FIRE SAFETY INSPECTION REPORT

VIYELLATEX LTD., DHAKA, BANGLADESH

ACC  **RD**
on Fire and Building Safety in Bangladesh

January 3, 2014

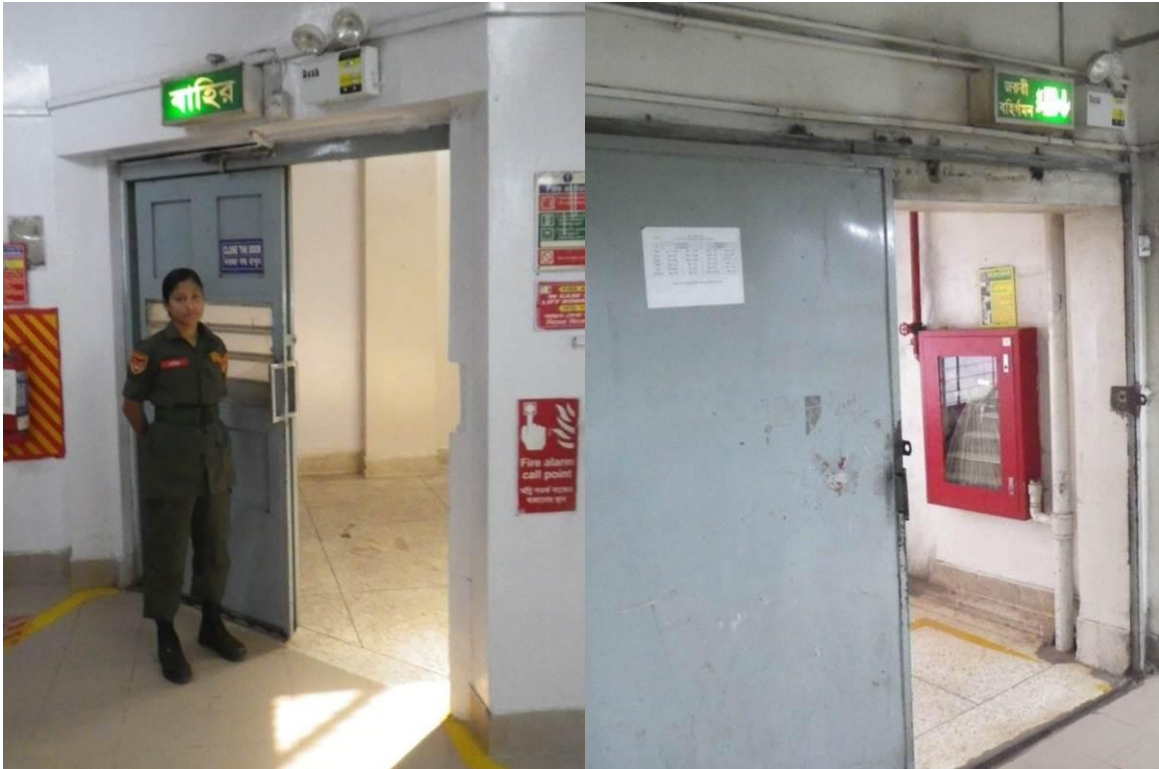
No.	Category	Finding	Recommendation	Priority	Photo Ref
F-1	Fire-Rated Construction, Egress	The three exit stairs are separated from the building interior with non-fire-rated sliding doors.	<p>Provide minimum 1.5-hr fire-rated doors to separate the exit stair from work areas and other building areas. Ensure that the fire doors are side-swinging, self-closing and positive latching and that they are provided with fire exit (panic) hardware where serving production floors.</p> <p>If the fire doors are required to be held open for functional reasons, provide automatic-closing devices tied to the fire alarm system.</p>	Critical	1
F-2	Fire-Rated Construction, Egress	The northwest exit stair has unprotected openings including ventilation louvers and access hatches.	Seal all penetrations and openings in the exit stair enclosure, or provided minimum 1.5-hr fire-rated opening protectives, to maintain the fire separation.	Critical	2

F-3	Fire-Rated Construction, Egress	Two of the three exit stairs discharge inside the building on the ground floor. Ground floor areas used for combustible storage are not separated from the exit discharge by fire-rated construction.	Provide minimum 2-hr fire separation between the exit stair discharge paths and all storage areas on the ground floor. Provide vestibules with minimum 1.5-hr fire doors to protect any openings in the fire separation walls.	Critical	3

No.	Category	Finding	Recommendation	Priority	Photo Ref
F-4	Fire-Rated Construction	Areas used for combustible storage on the 1st (cutting) and 2 nd (sewing) floors are not separated by fire-rated construction.	<p>Provide dedicated storage rooms separated by minimum 1-hr fire-rated construction on all production floors where transient storage is required for operations.</p> <p>Where separate storage rooms are not feasible, provide defined storage areas and limit the storage arrangement as follows:</p> <ul style="list-style-type: none"> - Maximum height of 2.4 m and maximum area of 23m² - If sprinkler protected: maximum height of 3.66m and maximum area of 93m² <p>Separate areas of unenclosed combustible storage by a minimum clear distance of 3m.</p>	Major	4
F-5	Fire-Rated Construction	Rooms housing the generator and large electrical equipment on the ground floor, as well as combustible fuel oil, are not separated by fire-rated construction.	Provide minimum 2-hr fire separation of the generator, electrical rooms and all fuel storage. Protect openings with minimum 1.5-hr, self- or automatic closing fire doors.	Major	5

No.	Category	Finding	Recommendation	Priority	Photo Ref
F-6	Egress	<p>The sliding doors at the exit stairs are provided with locking features.</p> <p>Note - all doors were unlocked during the inspection.</p>	<p>Remove all door/gate locking features at exit stairs and along the means of egress.</p> <p>If locks are required for security reasons, utilize special door locking features complying with NFPA 101.</p>	Critical	6
F-7	Fire Alarm	<p>Based on the number and location of notification appliances observed, the fire alarm system does not appear to provide adequate audible notification coverage on the production floor levels.</p> <p>Note – the system was tested on one of the floors and was not audible from all areas.</p>	<p>Provide additional fire alarm appliances to provide audible coverage throughout the building in accordance with NFPA 72 criteria.</p> <p>Where required based on ambient noise conditions (during operations), provide visual notification appliances.</p>	Critical	7

F-8	Fire Alarm	<p>Activation of the fire alarm system by a manual fire alarm station provides automatic occupant notification only on the floor of alarm and not throughout the building.</p>	<p>Configure the fire alarm system to initiate automatic occupant notification on all floor levels to facilitate whole-building evacuation upon alarm.</p>	Critical	7
F-9	Fire Alarm	<p>Smoke detector activation does not provide automatic fire alarm notification of occupants. Automatic notification is provided only by the manual fire alarm stations.</p>	<p>Configure the fire alarm system to initiate occupant notification upon activation of any two smoke detectors in addition to the manual fire alarm stations.</p>	Critical	7

No.	Category	Finding	Recommendation	Priority	Photo Ref
F-10	Fire Alarm	<p>The fire alarm system is not regularly tested and maintained.</p> <p>Note – the system is reportedly visually inspected regularly with maintenance / repairs provided as needed.</p>	<p>Inspect, test and maintain the fire alarm system, and keep written records on-site, in accordance with NFPA 72.</p>	Critical	7
F-11	Fire Protection	<p>The high-rise building is not provided with automatic sprinkler protection. The large occupant loads, heavy fuel loading, and anticipated extended egress times warrant sprinkler protection.</p>	<p>Provide automatic sprinkler protection throughout the building in accordance with NFPA 13.</p>	Critical	--
F-12	Emergency Lighting	<p>Emergency lighting is provided on the floors and in the exit stairs. The adequacy of the system was not fully tested. Based on the number and location of emergency lights observed, adequate illumination levels are not anticipated for all floor levels along egress routes.</p>	<p>Test the emergency lighting system on each floor and provide additional emergency fixtures to provide adequate illumination along the means of egress. Provide a minimum illumination of 10 lux at the floor level within exit stairs and exit discharge paths and minimum 2.5 lux along exit access aisles.</p>	Major	8

No.	Category	Finding	Recommendation	Priority	Photo Ref
F-1	Fire-Rated Construction, Egress	The two exit stairs are separated from the building interior with non-fire-rated sliding doors.	<p>Provide minimum 1.5-hr fire-rated doors to separate the exit stair from work areas and other building areas. Ensure that the fire doors are side-swinging, self-closing and positive latching and that they are provided with fire exit (panic) hardware where serving production floors.</p> <p>If the fire doors are required to be held open for functional reasons, provide automatic-closing devices tied to the fire alarm system.</p>	Critical	9
F-2	Fire-Rated Construction, Egress	Both exit stairs discharge inside the building on the ground floor. Ground floor areas used for production, washing and combustible storage are not separated from the exit discharge by fire-rated construction.	<p>Provide minimum 2-hr fire separation between the exit stair discharge paths and all production, washing and storage areas on the ground floor. Provide vestibules with minimum 1.5-hr fire doors to protect any openings in the fire separation walls separating storage areas.</p>	Critical	10

No.	Category	Finding	Recommendation	Priority	Photo Ref
F-3	Fire-Rated Construction	Areas used for combustible storage on the 1 st and 4 th floor are not separated by fire-rated construction.	<p>Provide dedicated storage rooms separated by minimum 1-hr fire-rated construction on all production floors where transient storage is required for operations.</p> <p>Where separate storage rooms are not feasible, provide defined storage areas and limit the storage arrangement as follows:</p> <ul style="list-style-type: none"> - Maximum height of 2.4 m and maximum area of 23m² - If sprinkler protected: maximum height of 3.66m and maximum area of 93m² <p>Separate areas of unenclosed combustible storage by a minimum clear distance of 3m.</p>	Major	11
F-4	Egress	<p>The sliding doors at the exit stairs are provided with locking features.</p> <p>Note - all doors were unlocked during the inspection.</p>	<p>Remove all door/gate locking features at exit stairs and along the means of egress.</p> <p>If locks are required for security reasons, utilize special door locking features complying with NFPA 101.</p>	Critical	9

No.	Category	Finding	Recommendation	Priority	Photo Ref
F-9	Fire Protection	The high-rise building is not provided with automatic sprinkler protection. The large occupant loads, heavy fuel loading, and anticipated extended egress times warrant sprinkler protection.	Provide automatic sprinkler protection throughout the building in accordance with NFPA 13.	Critical	--
F-10	Emergency Lighting	<p>Emergency lighting is provided on the floors and in the exit stairs. Based on the number and location of emergency lights observed, adequate illumination levels are not anticipated for all floor levels along egress routes.</p> <p>Note – the 1st floor was without power during the inspection with workers operating with no normal or emergency lighting.</p>	<p>Test the emergency lighting system on each floor and provide additional emergency fixtures to provide adequate illumination along the means of egress. Provide a minimum illumination of 10 lux at the floor level within exit stairs and exit discharge paths and minimum 2.5 lux along exit access aisles.</p>	Major	12

No.	Category	Finding	Recommendation	Priority	Photo Ref
F-11	Hazardous Storage	<p>The 1st floor of the adjacent Chemical Storage building has been connected to the building and is used for printing production. The Chemical Storage building contains a variety of hazardous materials, including combustible and flammable liquids stored on the ground floor. The printing area and means of egress serving this area are not adequately separated and protected from the hazardous storage.</p>	<p>Discontinue using areas of the Chemical Storage building for production.</p> <p>Alternatively, provide a minimum 2-hr fire-rated separation between the production area and associated means of egress and all hazardous storage areas, provide automatic sprinkler protection throughout the Chemical Storage building, and upgrade the fire alarm system as specified in the recommendations for the GMT Unit #2.</p>	Major	13

No.	Category	Finding	Recommendation	Priority	Photo Ref
F-4	Fire Alarm	Smoke detector (beam-type) activation does not provide automatic fire alarm notification of occupants. Automatic notification is provided only by the manual fire alarm stations.	Configure the fire alarm system to initiate occupant notification upon activation of any two smoke detectors in addition to the manual fire alarm stations.	Major	--
F-5	Fire Alarm	The fire alarm system is not regularly tested and maintained. Note – the system is reportedly visually inspected regularly with maintenance / repairs provided as needed.	Inspect, test and maintain the fire alarm system, and keep written records on-site, in accordance with NFPA 72.	Critical	--
F-6	Fire Protection	The storage warehouse area is provided with automatic sprinkler protection. The system appears to be designed for a light-hazard occupancy and is not appropriate for the high-rack combustible storage. The sprinkler-protected area is also not separated from the remainder of the building by fire-rated construction.	Modify the automatic sprinkler system for the warehouse area to provide appropriate protection in accordance with NFPA 13. Provide a minimum 2-hr fire-rated separation between the sprinklered warehouse area and non-sprinklered factory areas.	Major	16

No.	Category	Finding	Recommendation	Priority	Photo Ref
F-1	Egress	One of the two building exits requires exit access through a storage area within the Dining Building and was observed to be completely obstructed due to storage. Additionally, the two exits paths for the building are not remotely located and create a maximum common path of travel of over 60 m.	Provide a remotely located second exit for the building such that exit access is not required through a storage area and maximum common path of travel is less than 30 m.	Critical	17
F-2	Egress	The one functional exit serving the building consists of a lockable sliding door. Note - the doors was unlocked during the inspection.	Replace the sliding door with side-swinging doors. Remove all door locking features along the means of egress. If locks are required for security reasons, utilize special door locking features complying with NFPA 101.	Critical	18

No.	Category	Finding	Recommendation	Priority	Photo Ref
F-1	Egress	One of the two building exits requires exit access through the storage warehouse area. Additionally, the two exits paths for the factory area are not remotely located and create a maximum common path of travel of over 50 m.	Provide a remotely located second exit for the factory area such that exit access is not required through a storage area and the maximum common path of travel is less than 30 m.	Critical	--
F-2	Egress	Exits from the building consist of lockable sliding doors. Note - all doors were unlocked during the inspection.	Replace the sliding doors with side-swinging doors. Remove all door locking features along the means of egress. If locks are required for security reasons, utilize special door locking features complying with NFPA 101.	Critical	--
F-3	Egress	Dead-end aisles in excess of 30 m were observed both in the factory area and storage warehouse (due to storage obstructions).	Rearrange the factory equipment / work tables and remove all storage from aisles in the warehouse to eliminate dead-end conditions.	Major	19

No.	Category	Finding	Recommendation	Priority	Photo Ref
F-1	Egress	The Fashion Plastics & Packaging building is served by two exits that are not remotely located, creating a maximum common path of travel of over 50 m.	Provide a remotely located second exit for the factory area such that the maximum common path of travel is less than 30 m.	Critical	--
F-2	Fire Protection	The fire pump building has a wood roof, is located next to a waste storage area, and is not provided with sprinkler protection.	Replace the wood roof with a non-combustible, fire-rated roof assembly and provide sprinkler protection in the pump room.	Major	20
